Strategic Housing Development – Rosshill, Galway

Statement of Response to
An Bord Pleanála's Pre-
Application Consultation
Opinion

Client: **Kegata Limited**

Project Number: **181058**

Figure 2-1: Site Analysis (extract from Design Statement)

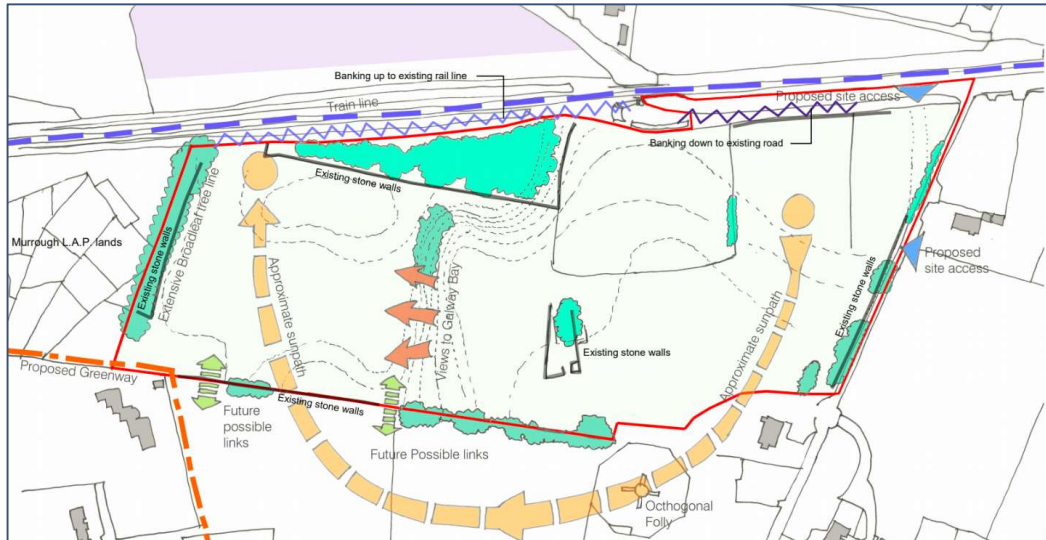
Further consideration/justification of the documents as they relate to the layout of the proposed development, in particular the documentation should demonstrate a thorough appreciation and assessment of the overall site context as the starting point in designing a distinct place. In this regard the applicant is required to revisit the 12 criteria set out in the 'Urban Design Manual' which accompanies the 'Guidelines for Planning Authorities on Sustainable Residential Development in Urban Areas' (May 2009) and the 'Design Manual for Urban Roads and Streets' (March 2013).

Particular attention should be paid to on site features of value or merit, topography and significant tree stands. Justification for, or amendments to, the layout of the apartment blocks proposed throughout the application site. The layout and relationship of these blocks relative to one another, the site topography and relative to the open spaces should be fully justified and/or reconsidered. The nature and functionality of the intervening space created between all apartment buildings, parking areas and streets should also be fully considered and justified.

Consequently, matters such as the arrangements and hierarchy of streets; configuration of the layout; connectivity with adjoining lands; provision of quality and usable open space and the creation of character areas within a high-quality scheme should be given further consideration. The further consideration of these issues may require an amendment to the documents and/or design proposals submitted.

The site has been carefully assessed in terms of location, topography, characteristics and constraints. The shape of the site, with robust boundaries on three sides and a level change in the centre played a crucial role in the formulation of a sustainable and sensitive design response. The level change at the centre of the site requires to be addressed across the site and utilising the spaces available in the best means possible.

The site is, in the main, residentially zoned and in a growing area east of the City of Galway. It is therefore required to provide a mix and range of housing types for a growing population and also ensure the creation of a successful neighbourhood in this key location.

Figure 2-6: Public Transport links (extract from drawing 18128-3029)

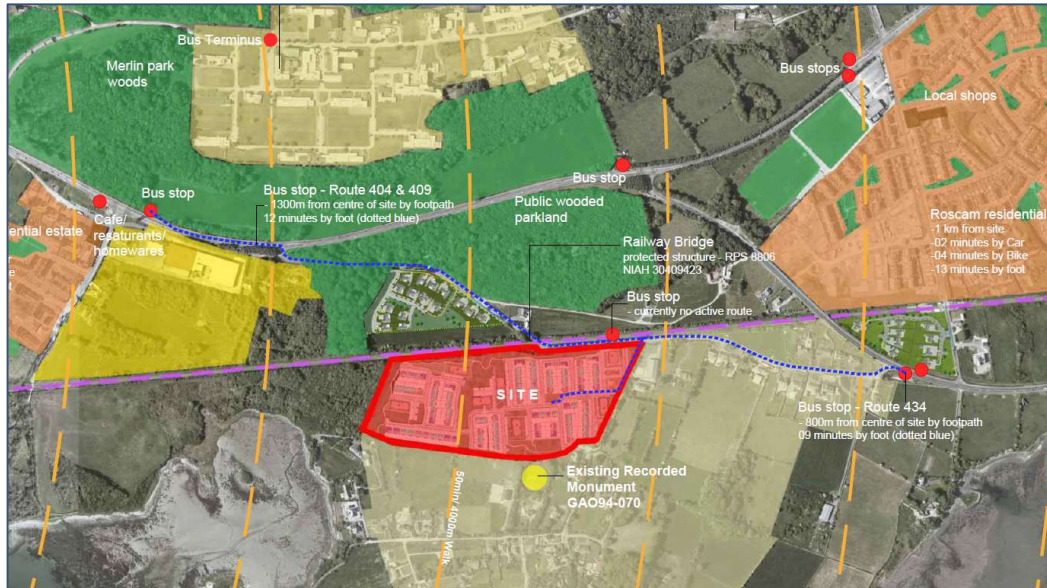
Further consideration/amendment of the documents as they relate to the provision and design of car parking within the proposed development. The documentation submitted at application stage should provide a robust rationale for the amount of car parking that is proposed. This should have due regard to the pattern of demand for travel that is likely to arise from the occupation of the proposed development, as well as the likely demand from households to have access to private transport even where it does not provide the primary mode for travel to work or school. The documentation should also take proper account of the advice concerning car parking and cycle parking provided for in the Sustainable Urban Housing: Design Standards for New Apartments Guidelines for Planning Authorities - 2018 and the design and layout of car parking outlined in the Design Manual for Urban Roads and Streets.

The site is located within 5km of the city centre and within 1 - 2km of local shops and services. The aerial context analysis plan (ref: 18128-3029) enclosed as part of the application illustrates this clearly. The site benefits from active bus services being in close proximity, and the applicant has engaged with a service provider regarding the potential to reopen the currently disused bus stop to the immediate north of the site. GoCar have noted their intention to support the scheme, while electric vehicle charging points ('EV') are proposed as part of the development.

That aside, car parking must be provided in line with the requirements of the Galway City Development Plan 2017-2023, specifically section 11.10.1 and Table 11.5, and the Sustainable Urban Housing Design Standards for New Apartments, at Section 4.22. The development is therefore required to provide 595no. car parking spaces across both houses and apartments. The full breakdown of car parking can be found in Appendix 5 of the Design Statement accompanying the application.

Figure 2-7: Site Context (extract drawing 18128-3029)

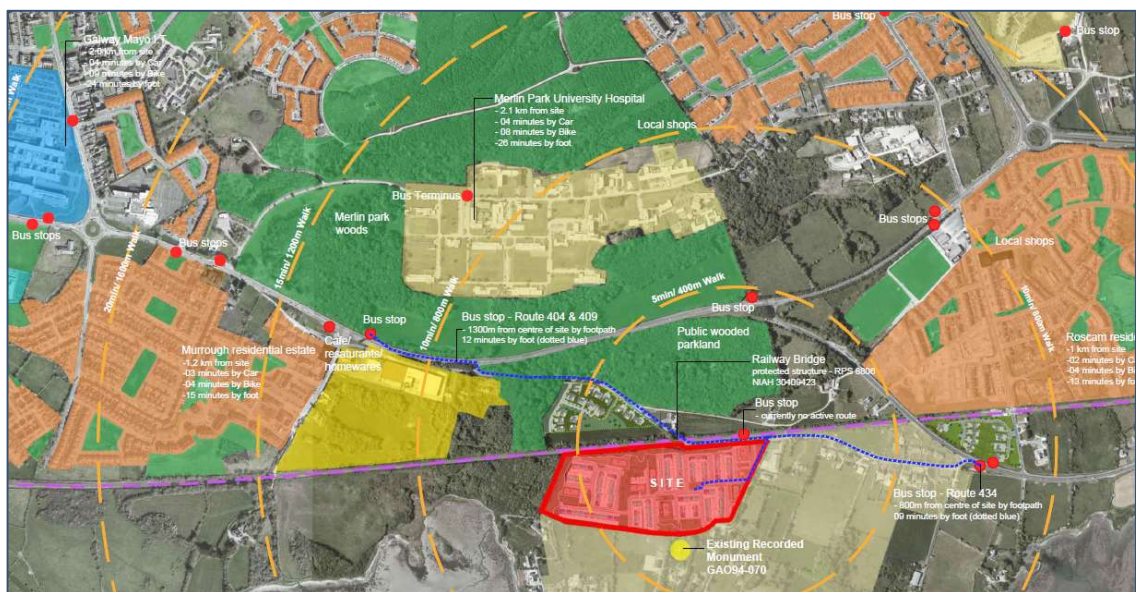
Further consideration/justification of the documents as they relate to existing and proposed pedestrian and cycle facilities connecting the development with the Dublin Road (R921) to the north, illustration of existing transport services such as rail and bus and future connections to adjoining residentially zoned land to the south of the site. The applicant should consider the preparation of a robust and achievable mobility management plan for the site that highlights availability of existing and planned sustainable modes of transport such as walking, cycling and public transport. The further consideration of these issues may require an amendment to the documents and/or design rationale submitted.

The sites location in the context of wider services and facilities is shown on drawing 18128-3029 (O'Neill O'Malley), enclosed with this application and an extract of which is shown below at Figure 2-7.

The site is already well connected via existing public transport, with bus stops existing to the north of the site linking the site both east and west. The Traffic and Transport Assessment ("TTA") which accompanies the application includes an audit of the existing infrastructure in the vicinity of the development site.

Figure 2-14: Stage 2 Ramp detail and Pedestrian Connections and Figure 2-15: Stage 3 Pedestrian Connections

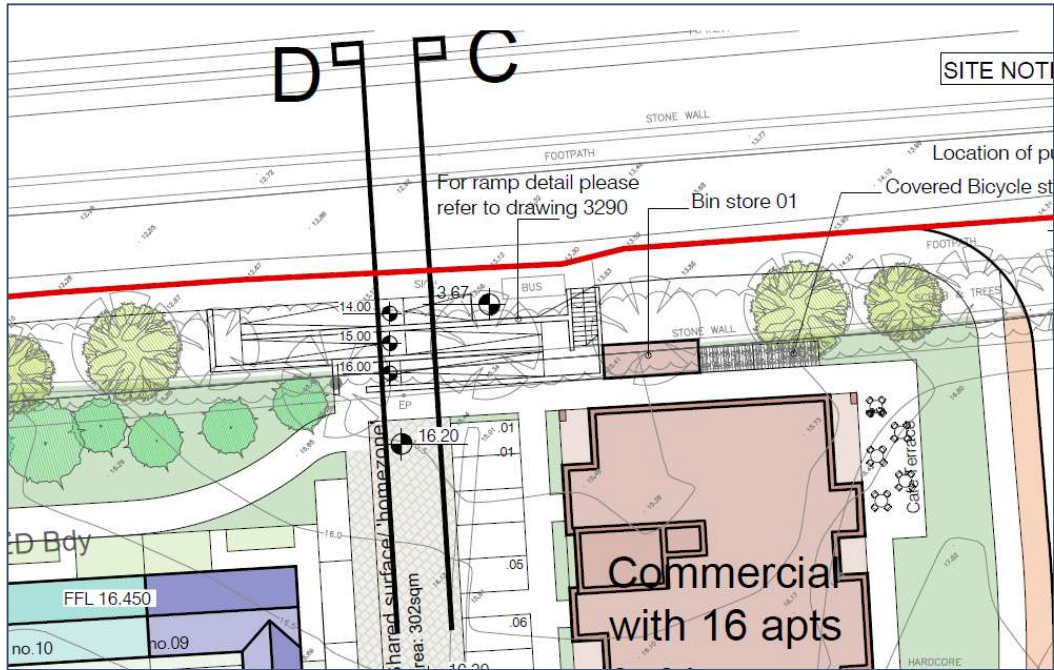
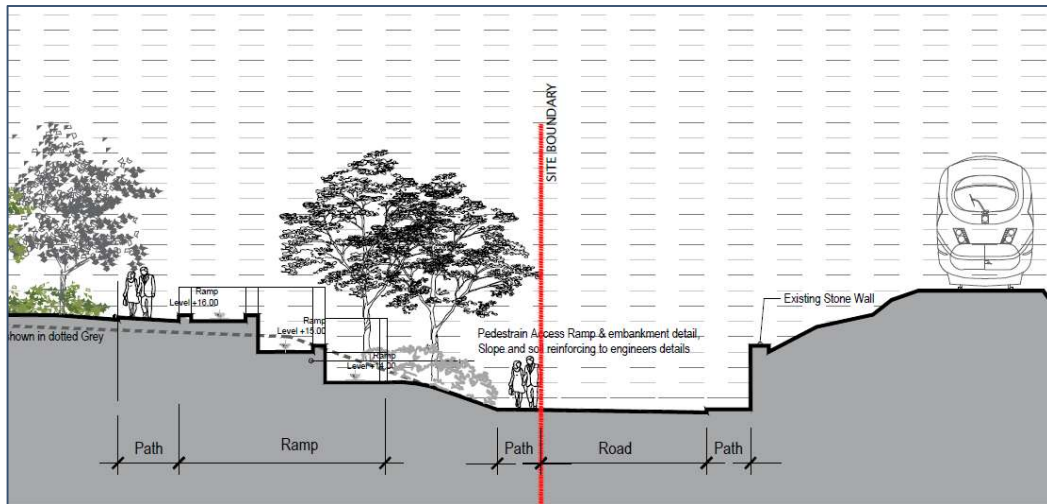
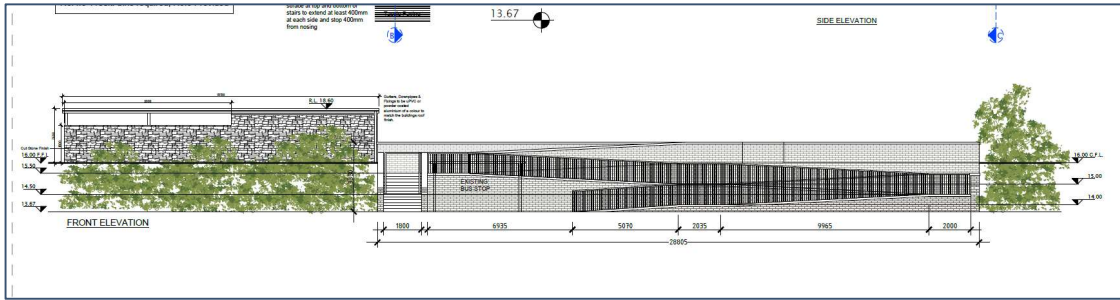
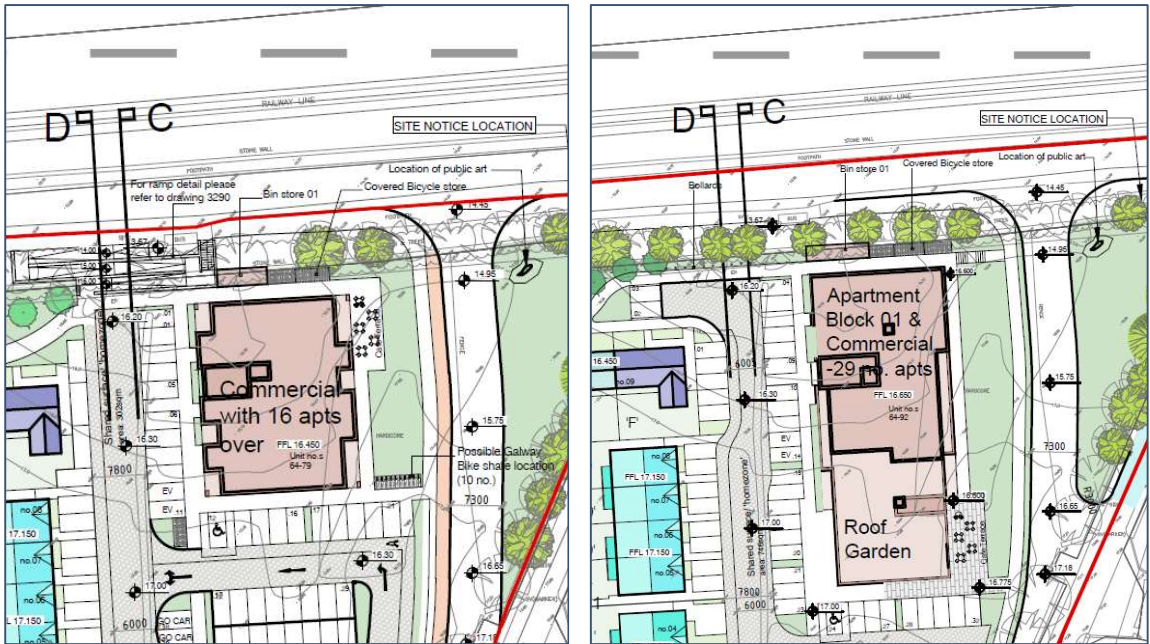
Further consideration of the documents as they relate to the layout of the proposed development particularly the relationship to the Old Dublin Road and Rosshill Road. The documents should clearly show acceptable design solutions that tackle differences in level between the site and the public road without the need for incongruous and heavy engineering solutions. Layout, contiguous elevations and section drawings should detail the relationship between the buildings and the public realm, existing and proposed. In particular, drawings should show the full suite of facilities that would be expected in any urban context; such as but not limited to; footpaths, landscape margins, appropriate boundary treatments and the provision of passive supervision of these new public spaces. Any development that integrates with the public realm either existing or modified should accord with the best practice principles of the Guidelines for Planning Authorities on Sustainable Residential Development in Urban Areas (including the associated Urban Design Manual) and the Design Manual for Urban Roads and Streets, that seek to provide better and safe pedestrian and cyclist environments. Further consideration of these issues may require amendment to the documents and/or design proposals submitted.

At the time of the Board issuing their formal Opinion, a step and ramp link was shown on the application drawings, per Figures 2-12 and 2-13 below.

Following the discussion at the Tripartite meeting with the Board and with the City Council, the team reflected on the ramp purpose and design, and held that it was in reality unlikely that residents would utilise the ramp to a great extent and that it was difficult to achieve an aesthetically pleasing design.

The ramp detail has therefore been omitted from the revised designs, while the internal pedestrian network revised to ensure connection with the external footpath links. Figures 2-14 and 2-15 below illustrate the design iterations with regards connections which took place at Stage 2 and Stage 3 of the SHD process.
